TM-902
1100.500

Radiation Safety Implications of the Proposed Main Ring/Energy Doubler Abort

J. D. Cossairt

This is a review of the radiation safety implications of the Main Ring/Energy Doubler abort dump as proposed by T. E. Toohig on September 7, 1979. Particular emphasis in the review is placed on the inclusion of uranium metal in the dump.

Figure 2

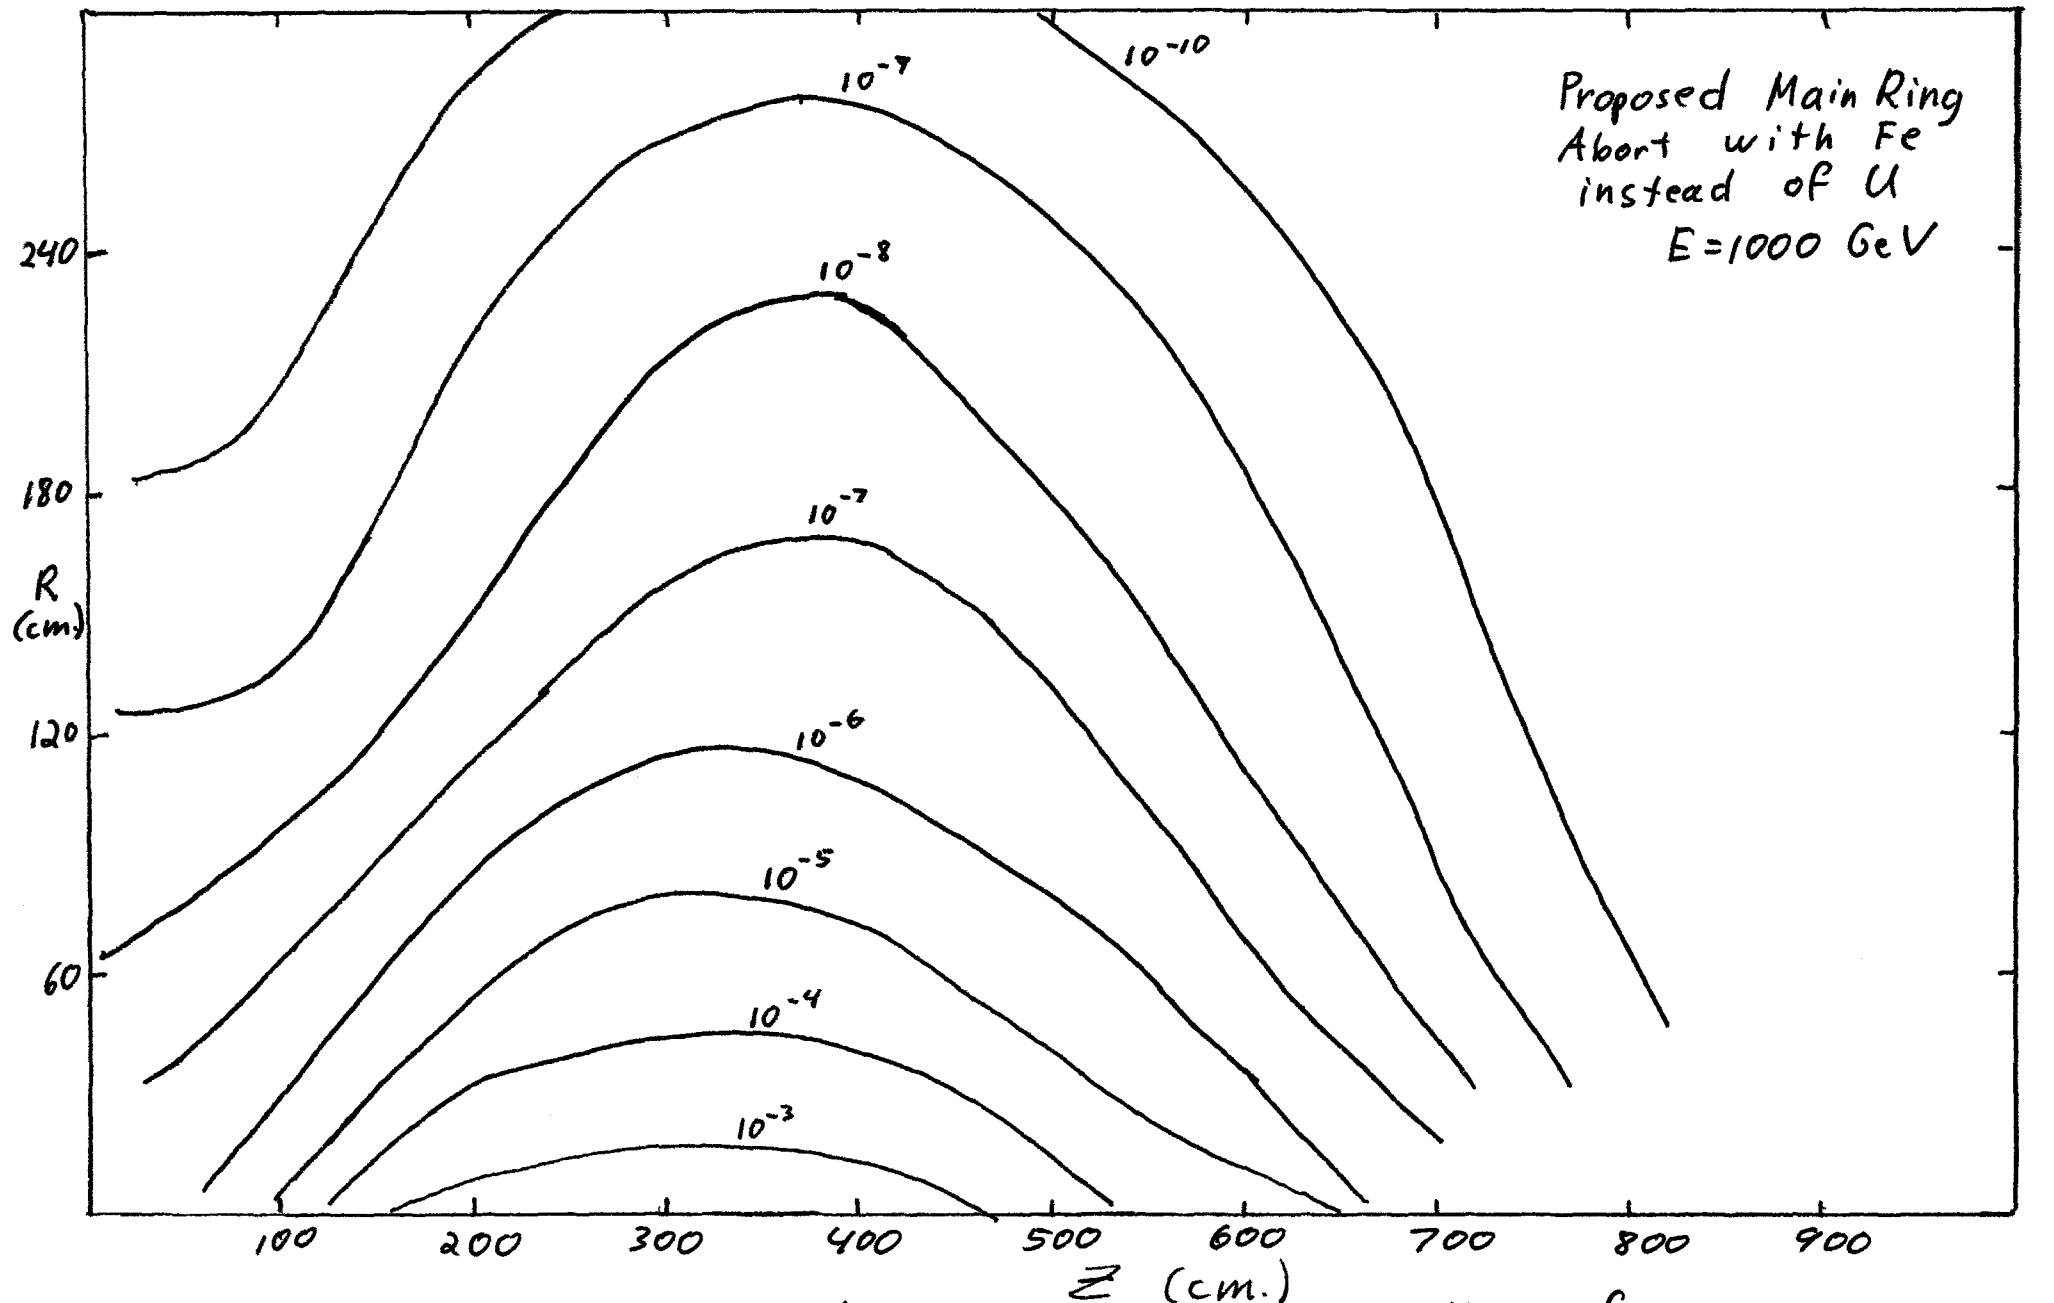
If the dump is at the main ring level, el 725.5', a reasonable berm top elevation is 747' or at a radius of 655 cm. Extrapolating from the worst place at R=300 cm using the known attenuation length of soil, the star density in the worst place on top of such a berm is:

$$SD_{max}(Fe) = 2.3 \times 10^{-13} \text{ stars/(cm}^3 \cdot \text{proton)}$$
$$SD_{max}(Pb) = 2.3 \times 10^{-13} \text{ stars/(cm}^3 \cdot \text{proton)}$$
$$SD_{max}(U) = 1.5 \times 10^{-13} \text{ stars/(cm}^3 \cdot \text{proton)}$$

The above numbers are equal when the probable error in the calculation is taken into account. One should be aware that standard CASIM underestimates the star density in a material with large atomic number such as ^{208}Pb or ^{238}U.[3] The $SD_{max}(Fe)$ implies that at 5×10^{13} protons/pulse, 20 sec. cycle time, a dose rate of 19 mrem/hour would be measured on top of such a berm over the dump. The CO location is about 5500' from Butterfield Road and the top of the berm is already 22 feet from the source point so that the dose on Butterfield is 0.03 mrem/year at 1×10^{18} protons/year. This is quite low compared with the Laboratory's limit of 10 mrem/year for any off-site location.

Figure 4

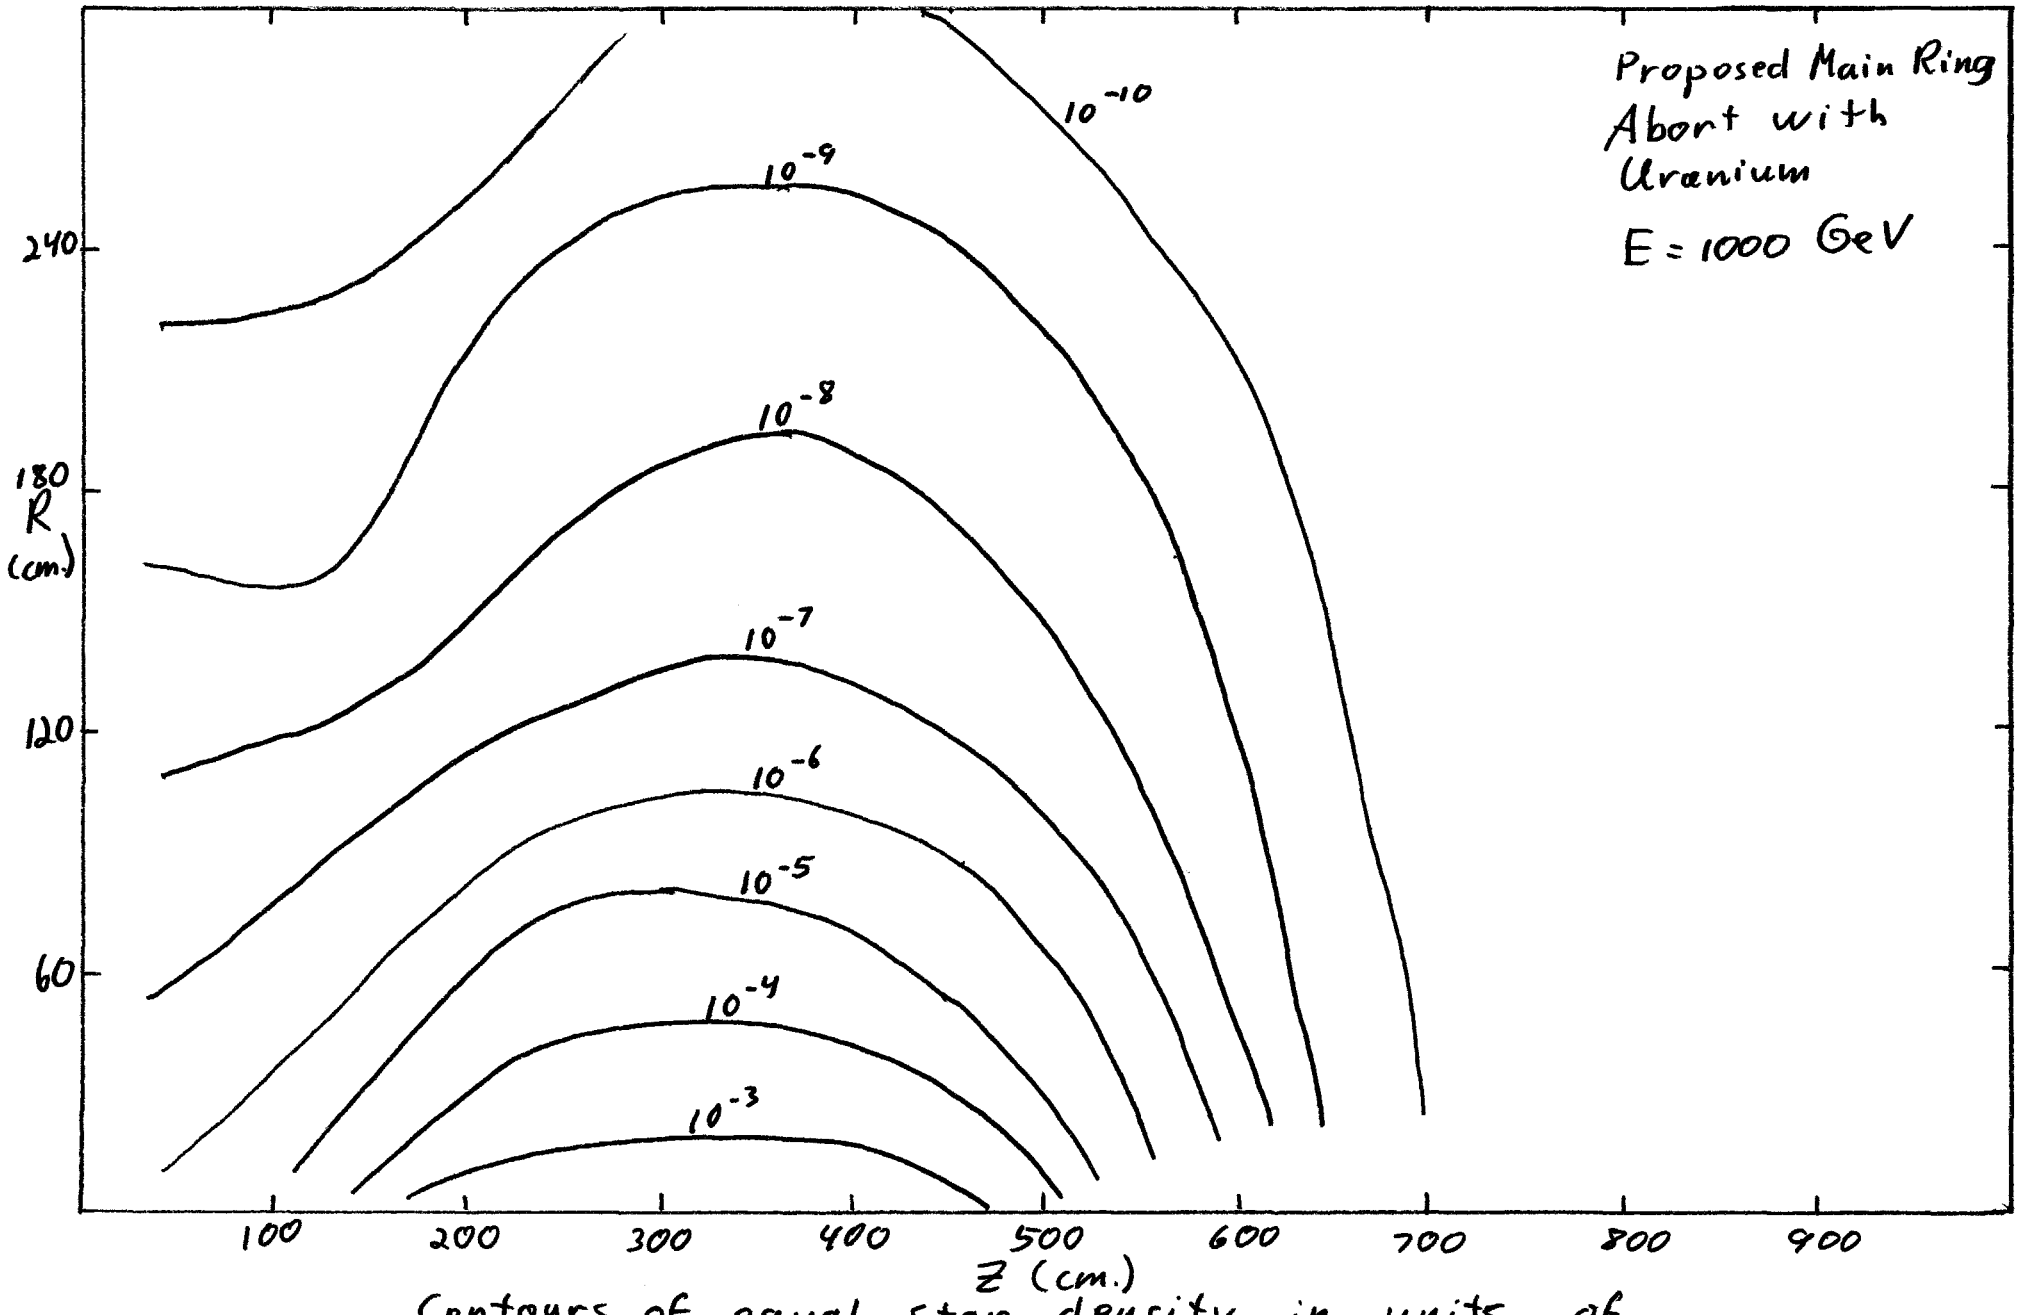
The amount of ^{239}Pu produced was estimated crudely using the results of a study of the possibility of energy production using accelerators by R. R. Wilson.[8] The spectrum of hadrons incident on the upstream end of the U is shown in Fig. 5 and has an average momentun of 3.3 GeV/c and a flux of 8.8×10^{-3} hadrons/cm^2·proton) or a total beam of about 16 hadrons/(incident proton). Scaling the results of FN-298 to the lower momentum, one obtains about 1 gm/year of Pu which, if all taken to be ^{239}Pu, represents an activity of 0.07 Ci. If other Pu isotopes are present, the activity will be higher because of the shorter half lives.
